UNITED STATES PATENT AND TRADEMARK OFFICE

APPLICATION NO.	FILING DATE	FIRST NAMED INVENTOR	ATTORNEY DOCKET NO.	CONFIRMATION NO.
10/822,055	04/08/2004	Deok-Yong Kim	2522-056	2096

Office Action Summary

DETAILED ACTION

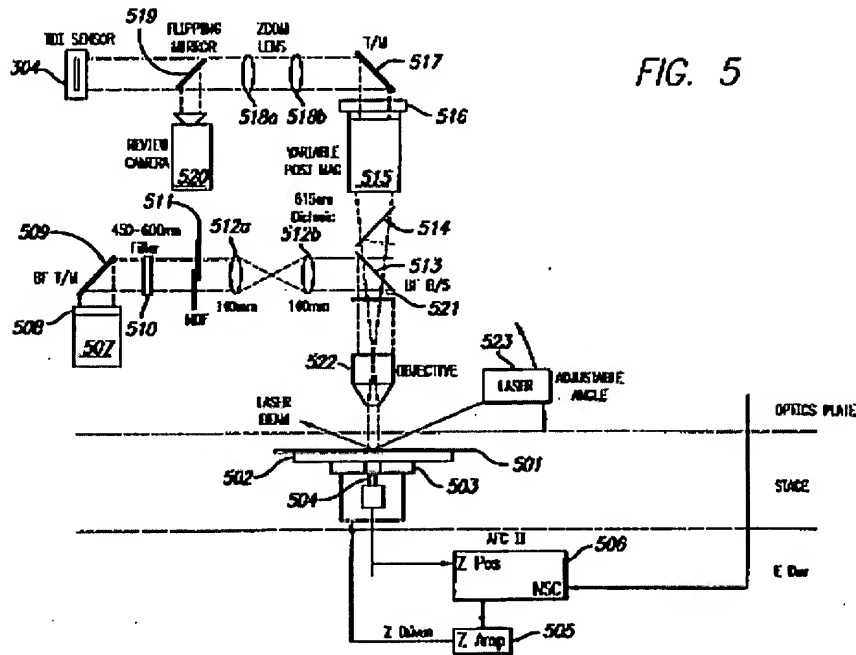
Fairley et al. ('780) discloses an emitter (Fig. 5, Ref. 523) for irradiating lights to the particles, the object (Fig. 5, Ref. 501) being disposed on a stage (Fig. 5, Ref. 502) in a direction substantially parallel to a surface of the object (Fig. 5, Ref. 501); a driver for generating a relative motion between the emitter (Fig. 5, Ref. 523) and the object (Fig. 5, Ref. 501) for scanning the surface of the object (Fig. 5, Ref. 501) with the lights (Col. 10, lines 22-28); and a detector (Fig. 5, Ref. 304, 520) for detecting the lights emitted from the emitter (Fig. 5, Ref. 523) or lights scattered from the particle. (It is the position of the examiner that the way the claim is written, the object is parallel with the stage not the emitted light from the emitter, and further the specification fails to define "substantially parallel" being zero degrees or just parallel to the surface of the object. Therefore, the current prior art discloses the illumination angle can be between 5 degrees to 45 degrees which when the angle is 5 degrees is substantially parallel to the

surface since applicants specification fails to disclose otherwise.)
